SUBJECT: COMANCHE PEAK NUCLEAR POWER PLANT, UNITS 1 AND 2 - STAFF
ASSESSMENT OF RESPONSE TO 10 CFR 50.54(f) INFORMATION REQUEST
– FLOOD-CAUSING MECHANISM REEVALUATION (CAC NOS. MF1099 AND
MF1100)

STAFF ASSESSMENT BY THE OFFICE OF NUCLEAR REACTOR REGULATION

RELATED TO FLOODING HAZARD REEVALUATION REPORT

COMANCHE PEAK NUCLEAR POWER PLANT, UNITS 1 AND 2

**Figure 3.2-2: Schematic of Updated HEC-RAS Model for Site Drainage and LIP Analysis
(Adapted from Luminant, 2015, Figure 2-1-2)**

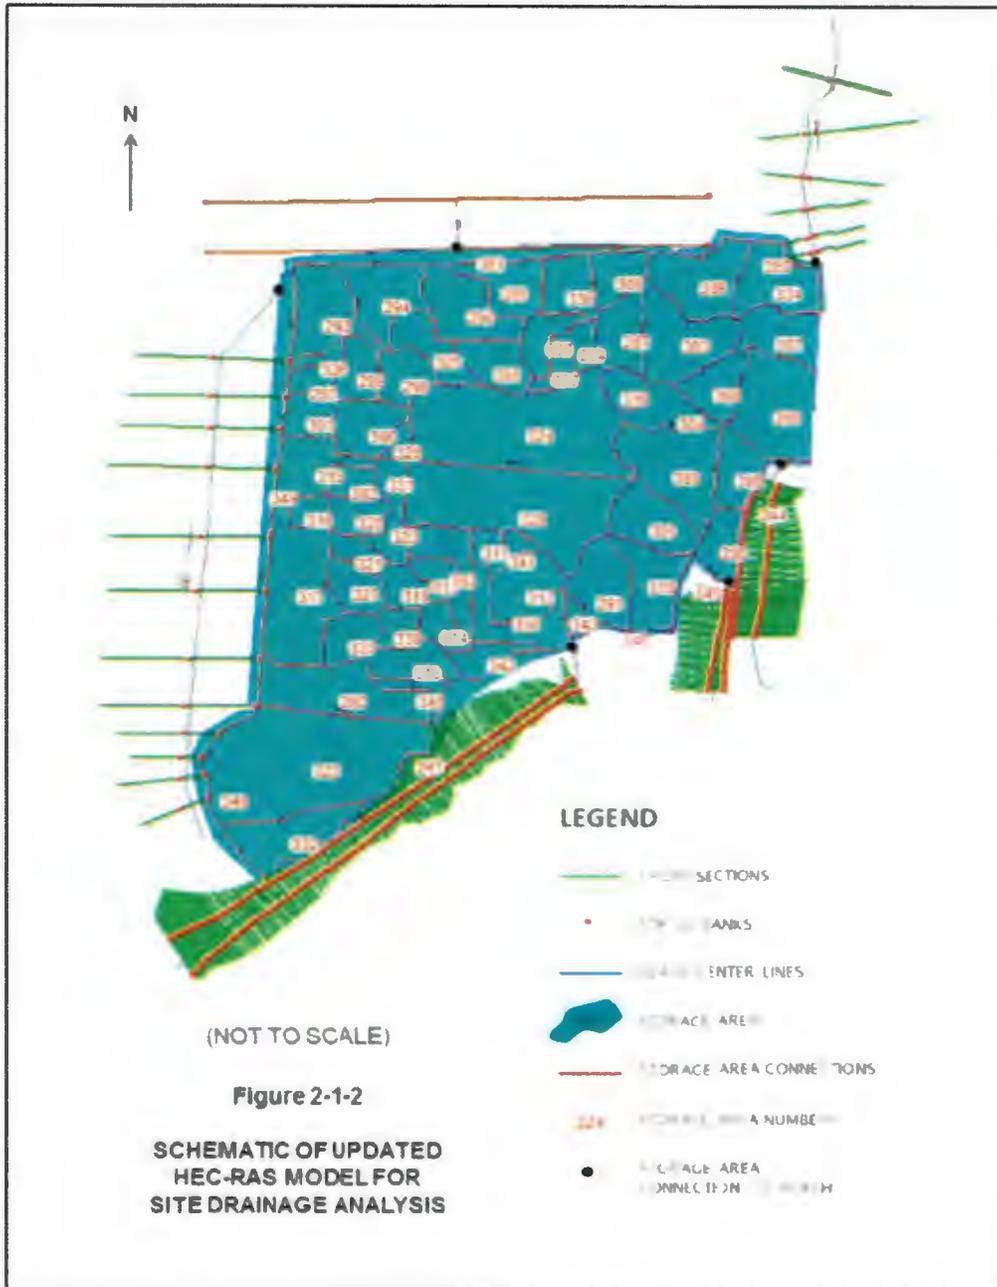
The licensee simulated potential flood water levels within the power block protected area using the Hydrologic Engineering Center - River Analysis System (HEC-RAS) model (USACE, 2010b). Figure 3.2-2 shows a schematic of the updated HEC-RAS model for site drainage and LIP analysis. The storage areas delineated for local drainage discharge in HEC-HMS and the output hydrographs were used as input into the HEC-RAS model.

The licensee's approach accumulates water in each sub-basin until the water level exceeds a boundary weir elevation. Once the water level exceeds a point along a weir, flow transfer occurs via weir flow. Based on its review, the NRC staff determined that the quasi-2D approach allows for rapid transfer of water across sub-basins in a manner that does not reflect expected physical routing of flood waters. Moreover, the manner in which the quasi-2D approach accounts for the storage area dimensions and lumps characteristics leads to temporal and spatial flow distribution that do not reflect expected physical routing of flood waters. In addition, staff finds that a reach representing flow to the SCR from a north catchment outside the VBS presents a mechanism for flow transfer that do not reflect expected physical routing of flood waters. Specifically, the modeling of several VBS openings led to fast storage area flow transfer and allowed for water to quickly move to the model perimeter. Once at the model perimeter, water enters a dummy reach and exits from the model.

After examining the model setup and the approach used by the licensee, the NRC staff determined that the simulated flood water exits the model prematurely, resulting in water elevations that are low compared to what might be expected using an alternate modeling approach.

The staff also conducted an independent analysis using the surface water flow model FLO-2D Build No. 14.03.07 (FLO-2D, 2014) and found maximum water surface elevations to be higher than predicted by the licensee. The staff's independent analysis supported the staff's conclusions regarding the issues noted above regarding the licensee's use of the HEC-RAS model.

Based on the results of the examination of the licensee's LIP model, staff's independent analysis, and identification of the issues related to the licensee's model, the NRC staff and management held subsequent meetings as part of a regulatory audit with the licensee to determine a path forward regarding the licensee's LIP modeling approach. As a result of the discussions the staff and the licensee agreed that a higher water surface elevation of 810.6 ft

NGVD29 would be appropriate for use as the reevaluated LIP flood level (Luminant, 2016; NRC, 2016b). This water surface elevation of 810.6 ft NGVD29 is the simulated water level at the non-safety-related TB 1.

Therefore, the staff concludes that a reevaluated flood level of 810.6 ft NGVD29 is a reasonable estimate of the LIP flood hazard (NRC, 2016b; Luminant, 2016).
